Work Order ID 150735

DART SERVICE INSTRUCTION

TO AMEND INSTALLATION INSTRUCTIONS IIN-D412-698 REV. E & INSTRUCTIONS FOR
CONTINUED AIRWORTHINESS ICA-D412-698 REV. 5

B	ADD D3199-3/-4 TO KITS	MB	13.01.09
A	NEW ISSUE	MB	12.11.21
REV.	DESCRIPTION	BY	DATE
DESIGN		DART AEROSPACE LTD	
DRAWN		HAWKESBURY, ONTARIO, CANADA	
CHECKED		DRAWING NO.	REV. B
MFG. APPR.	N/A	DSI 9635	SHEET 1 OF 5
APPROVED		TITLE	SCALE
DE APPR.		ROLLER BRACKET CHANGE KIT	NTS
DATE	13.01.09	COPYRIGHT © 2012 BY DART AEROSPACE LTD THIS DOCUMENT IS PRIVATE AND CONFIDENTIAL AND IS SUPPLIED ON THE EXPRESS CONDITION THAT IT IS NOT TO BE USED FOR ANY PURPOSE OR COPIED OR COMMUNICATED TO ANY OTHER PERSON WITHOUT WRITTEN PERMISSION FROM DART AEROSPACE LTD.

FIGURE 2 - MODIFIED SLIDING DOOR
(D412-698-111 SHOWN, D412-698-112 OPPOSITE)

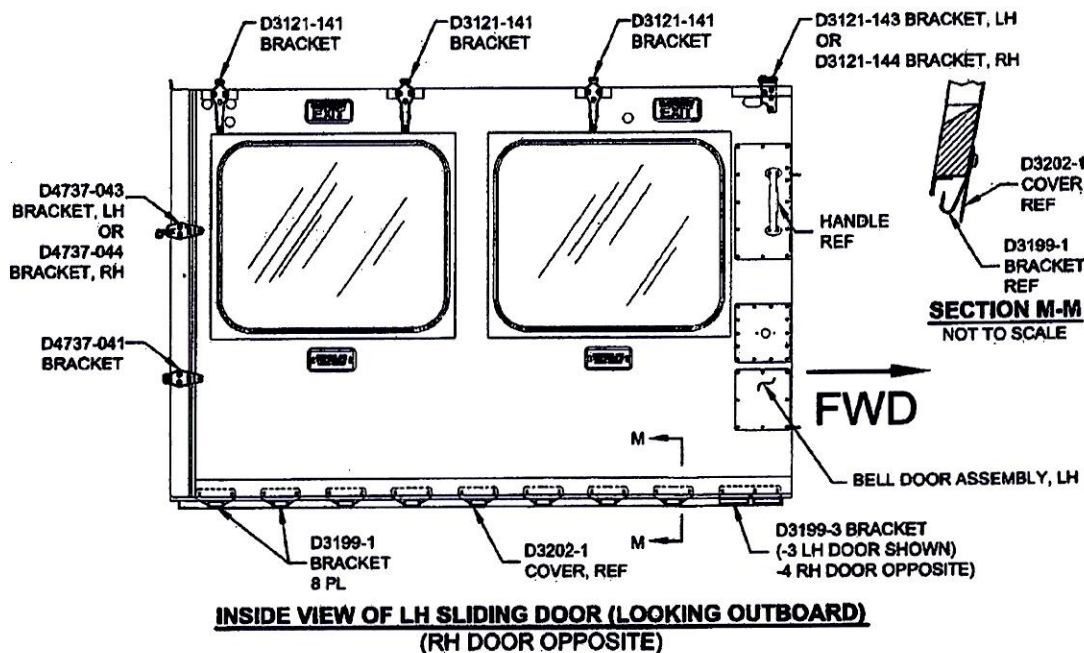
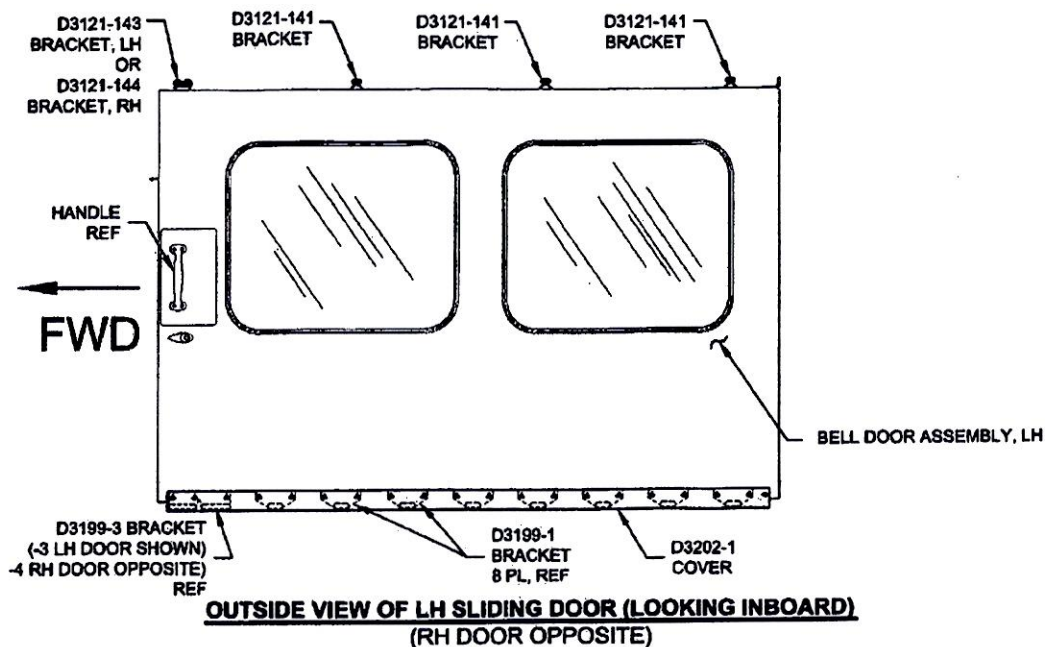
- 3.6 Remove 205-032-669-125 Track (LH) and/or 205-032-669-126 Track (RH) as applicable. Install D3199-1/-3/-4 Brackets and D3202-1 Cover as shown in Figure 2 using existing mounting hardware if determined to be airworthy.
